**NEW YORK STATE THRUWAY AUTHORITY
DEPARTMENT OF ENGINEERING**

**ALBANY, NY
FEBRUARY 11, 2026**

**AMENDMENT NO. 1
TO**

**CONTRACT TAN 26-14
D215082
PAVEMENT REHABILITATION AND MISCELLANEOUS
WORK ON I-190, NIAGARA THRUWAY
FROM MP N0.7 TO MP N4.2
IN THE BUFFALO DIVISION
OF THE NEW YORK STATE THRUWAY
IN ERIE COUNTY**

TITLE OF PROJECT I-190 HIGHWAY REHABILITATION	CONTRACT NUMBER: TAN 26-14
LOCATION OF PROJECT I-190 NIAGARA THRUWAY MP 900.7 TO MP 904.2	DATE: FEB. 2026
TITLE OF DRAWING CAST-IN-PLACE MISCELLANEOUS FULL DEPTH REPAIR DETAILS	DRAWING NUMBER: MD-1

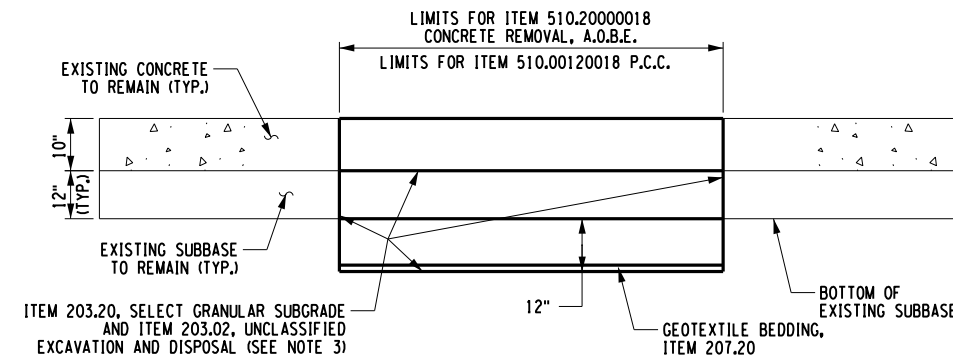
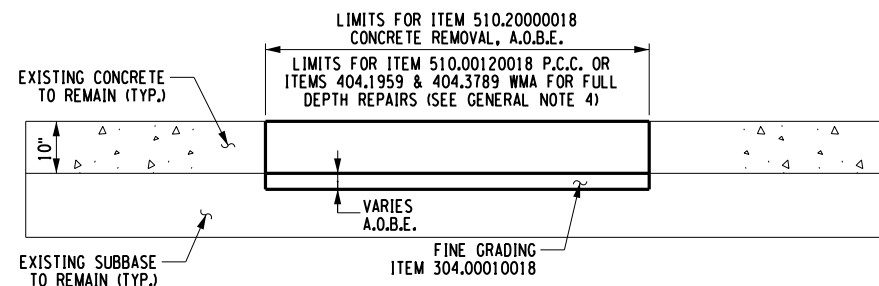
4. **DELETE** Drawing Number MD-1, Sheet 190 of 421, and **SUBSTITUTE** with the attached Drawing Number MD-1, Sheet 190-A1 of 421. Added a new Note 4. under “General Notes”.

- FULL DEPTH ASPHALT REPAIRS SHALL CONSIST OF 4" OF ITEM 404.1959 - BINDER COURSE ASPHALT AND 6" OF ITEM 404.3789 - BASE COURSE ASPHALT. TACK COAT SHALL BE APPLIED BETWEEN THE LIFTS AND ALONG THE VERTICAL EDGES OF THE SURROUNDING CONCRETE PAVEMENT PANELS TO REMAIN.**

TITLE OF PROJECT I-190 HIGHWAY REHABILITATION	CONTRACT NUMBER: TAN 26-14
	LOCATION OF PROJECT I-190 NIAGARA THRUWAY MP 900.7 TO MP 904.2	DATE: FEB. 2026
	TITLE OF DRAWING MISCELLANEOUS DETAILS	DRAWING NUMBER: MD-12

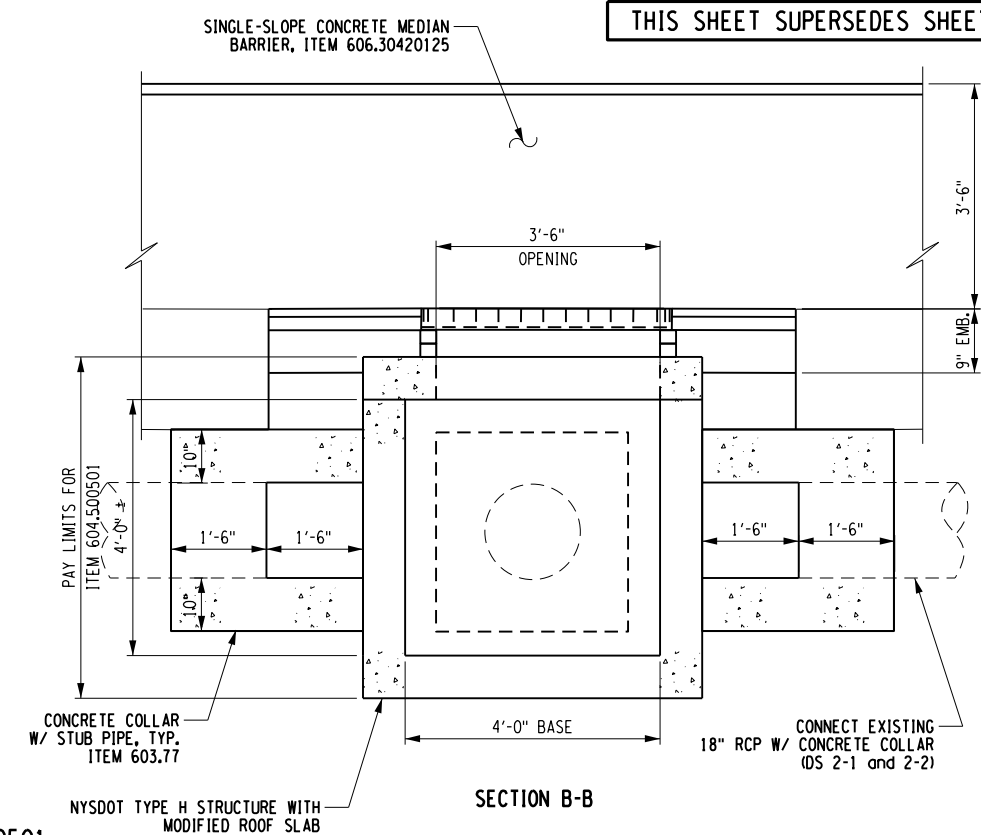
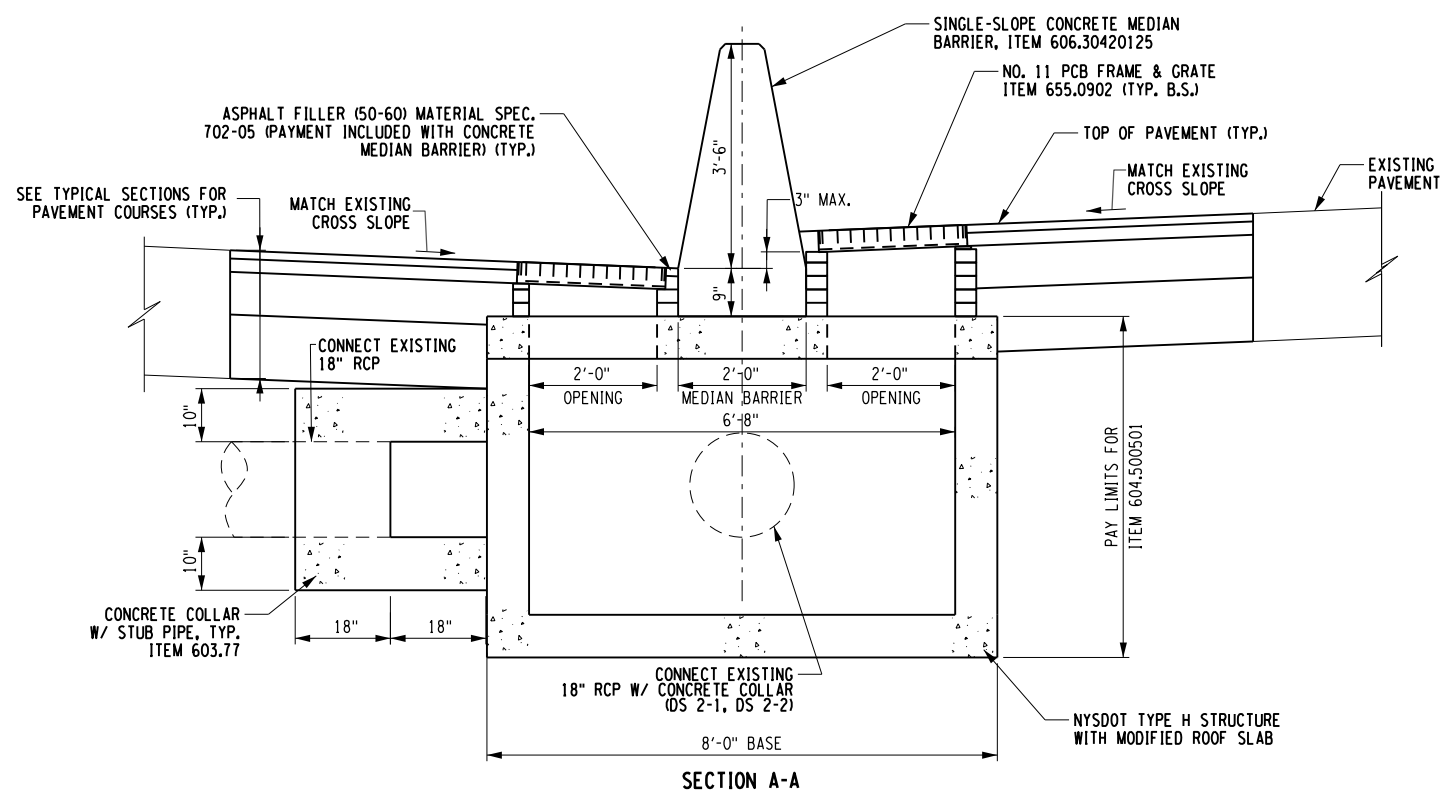
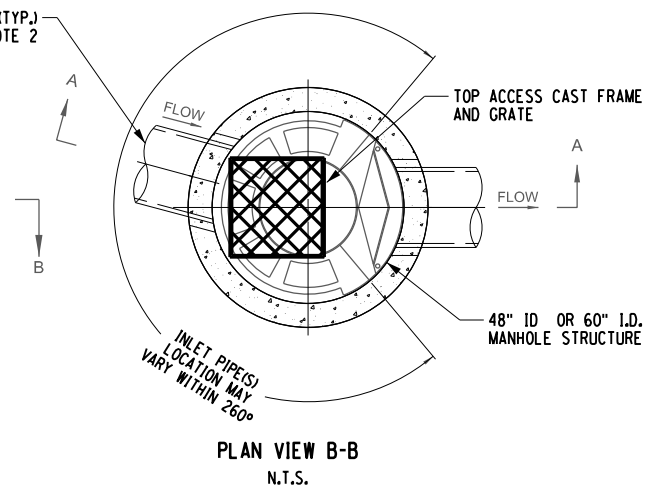
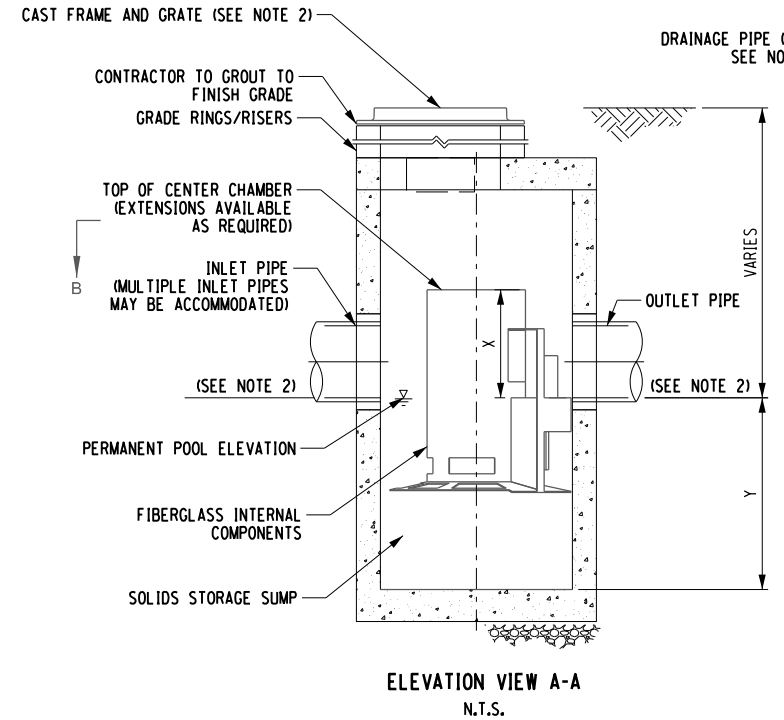
5. **DELETE** Drawing Number MD-12, Sheet 201 of 421, and **SUBSTITUTE** with the attached Drawing Number MD-12, Sheet 201-A1 of 421. A required Water Quality Volume Table has been added, the name of the (Item 208.2501) detail has been changed to Stormwater Treatment System Details, it now also references the new Item 208.5301, and the Elevation View A-A dimensions (now labeled as X and Y) have been changed.

WATER QUALITY VOLUME			
STRUCTURE	DS 7-18	DS 21-11	DS 30-11
NYS DOT ITEM NUMBER	208.5301	208.5301	208.5201
RAINFALL EVENT NUMBER	P 2.10	0.99	1.00
IMPERVIOUS COVER	I 22%	71%	100%
AREA	2.15 ACRES	2.20 ACRES	0.57 ACRES
WATER QUALITY VOLUME (WQV)	0.031 ACRE-FEET	0.123 ACRE-FEET	0.037 ACRE-FEET
WQV FLOW RATE (PEAK DISCHARGE)	2.22 CFS	2.01 CFS	0.64 CFS

DIMENSIONS		
DIMENSION	DS 30-11	DS 7-18 & DS 21-11
DIAMETER	48"	60"
X	2'-3"	2'-10"
Y	4'-0"	4'-6"

- NOTES:
1. THE STORMWATER TREATMENT SYSTEM SHALL BE A CONTECH CASCADE SEPARATOR (CS-5) OR APPROVED EQUAL. ALL MATERIALS PROVIDED UNLESS OTHERWISE NOTED.
 2. CONTRACTOR SHALL VERIFY EXISTING PIPE SIZES AND INVERTS FOR THE PROPOSED STORMWATER TREATMENT UNITS FOR DS 7-18, DS 21-11, AND DS 30-11. SEE DWG MT-15 FOR PROPOSED DRAINAGE INSTALLATION TABLE.

CONTRACT NUMBER: TAN 26-14
DATE: FEB. 2026
DRAWING NUMBER: BP-8

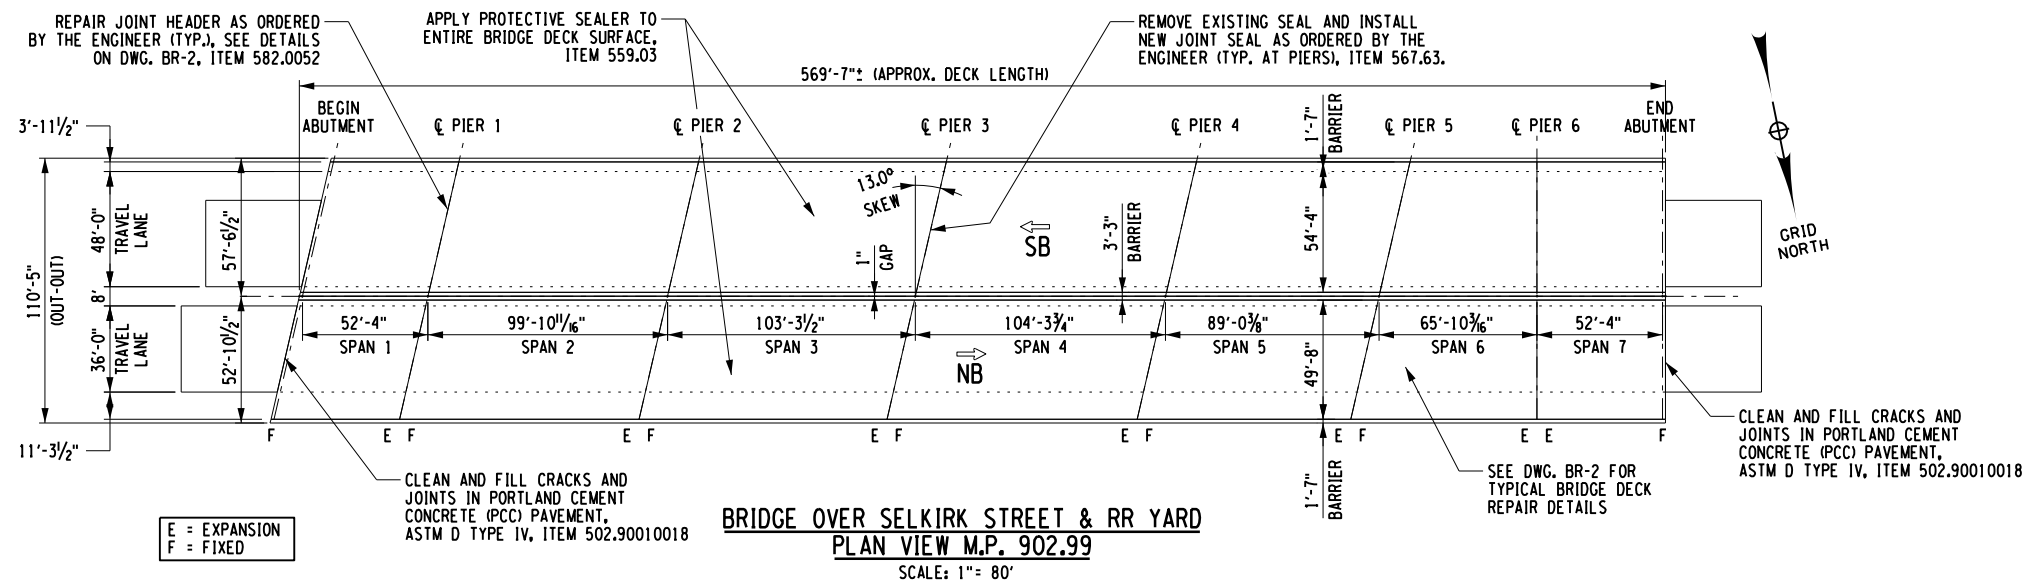
14. **DELETE** Drawing Number BP-8, Sheet 398 of 421, and **SUBSTITUTE** with the attached Drawing Number BP-8, Sheet 398-A1 of 421. The plan view for MP 902.99 Bridge over Selkirk Street and RR Yard and protective sealing table have been reorganized to now accommodate six new Expansion Joint Opening Tables for each Pier of the bridge.

EXPANSION JOINT OPENING TABLE	
SUPERSTRUCTURE TEMPERATURE (°F)	JOINT OPENING (IN.)
30	2 3/8
35	2 3/8
40	2 3/8
45	2 1/4
50	2 1/4
55	2 1/8
60	2 1/8
65	2
70	2
75	2
80	1 7/8
85	1 7/8
90	1 3/4
95	1 3/4
100	1 5/8
105	1 5/8
110	1 1/2

NOTES:
MIN. OPENING (IN.) = 1.5
MAX. OPENING / REQ. MIN. SEAL WIDTH (IN.) = 3
TOTAL MOVEMENT (IN.) = 1.5
